Issued by Canon Europa N.V.

Model : Finisher D1

No.: Acc-148 Rev. 1
(FF-T01-W-000051-02)

Subject : PREVENTING STATIONARY JAMS (AROUND SORTING GUIDE)

Fig. 2

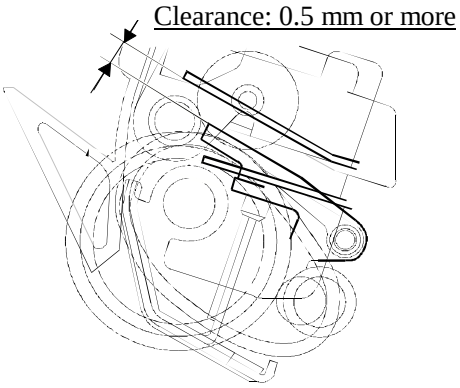
2. While holding up the swing guide, check the gap between the sorting guide assembly and the ribs. If the gap is not as indicated, perform the following steps:

Fig. 7

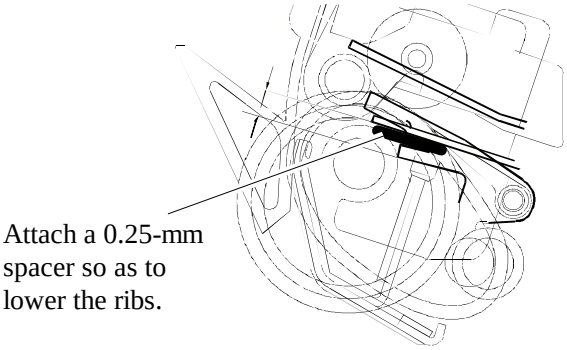
<Cause>
The absence of a gap between the ribs in the sorting guide assembly and passing paper hinders the paper from moving properly, resulting in a stationary jam in front of the sorting guide.

5. Attach the 0.25-mm spacer to the sorting guide assembly so that the ribs will lower.
   Note: If one is not enough, attach another spacer over it.
